Access Compliance Report

Public Rights-of-Way

(Curb Ramps)

Intersection ID: 53252	Main Street: MARLOWE_AV	Cross Street: FLEETWOOD_DR	Location: NW
ADA ID: AA12B80625BB	Ramp Type: BlendTrans1	Initial Pass/Fail: Fail	Overall Compliance: No
Codes/Mitigation Info/Possible Solution			Severity Score: 10
			Field Measurements/Component Compliance

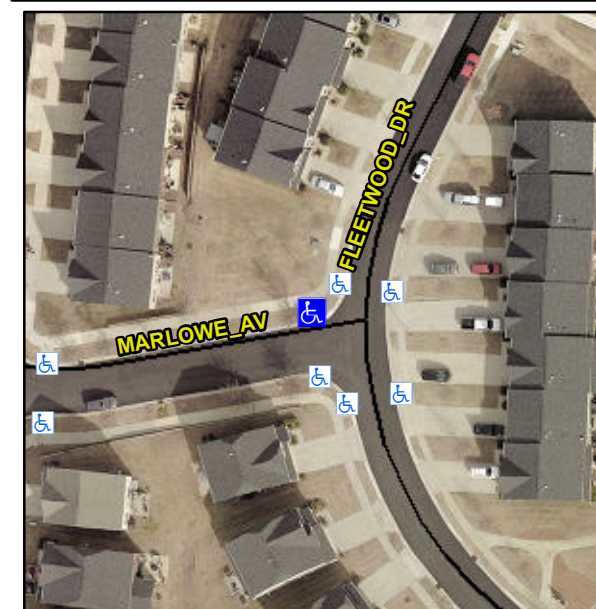
R304.5.1, R304.5.3

Compliance	Description	Data	Compliance	Description	Data
N/A	Ramp Length (in)	95.5	Yes	BlendTrans Slope (%)	2.0
No	Ramp Width (in)	45.5	No	BlendTrans XSlope (%)	4.8
N/A	Flare Type LT	N/A	N/A	Flare Type RT	N/A
N/A	Flare Slope LT (%)	N/A	N/A	Flare Slope RT (%)	N/A
N/A	Flare Traversable LT?	N/A	N/A	Flare Traversable RT?	N/A
N/A	Landing Length (in)	N/A	N/A	DWS Provided?	N/A
N/A	Landing Width (in)	N/A	N/A	DWS Contrast?	N/A
N/A	Landing Slope (%)	N/A	N/A	DWS Length (in)	N/A
N/A	Landing X Slope (%)	N/A	N/A	DWS Full Width?	N/A
N/A	Landing Curb? (Y/N)	N/A	N/A	DWS Offset (in)	N/A
N/A	Shared Landing?	N/A			
N/A	Gutter Ponding?	N/A	N/A	Gutter Slope (%)	N/A
N/A	Gutter Lip Ht (in)	N/A	N/A	Gutter X Slope (%)	N/A
N/A	Painted X Walk1?	No	N/A	Painted X Walk2?	N/A
	X Walk 1 Direction	To S		X Walk 2 Direction	N/A
	X Walk 1 Width (in)	N/A		X Walk 2 Width (in)	N/A
	X Walk 1 Slope (%)	3.1		X Walk 2 Slope (%)	N/A
	X Walk 1 X Slope (%)	4.0		X Walk 2 X Slope (%)	N/A

N/A	Ramp inside XWalk1?	N/A	N/A	Ramp inside XWalk2?	N/A
	Road Slope (%)	4.0		Clear Space?	N/A
	Road X Slope (%)	3.1	N/A	Clear Space to XWalk (in)	N/A
N/A	Any Obstructions?	N/A	N/A	Storm Grate/Utility Hazard?	N/A
	Obstruction Type			Storm Grate/Utility Type	
		N/A			N/A
			Yes	Surface Condition? (G/P)	Good
			N/A	Curb Slope (%)	2.3

Remove & Replace Curb Ramp With Two New Directional Ramps or Equivalent.
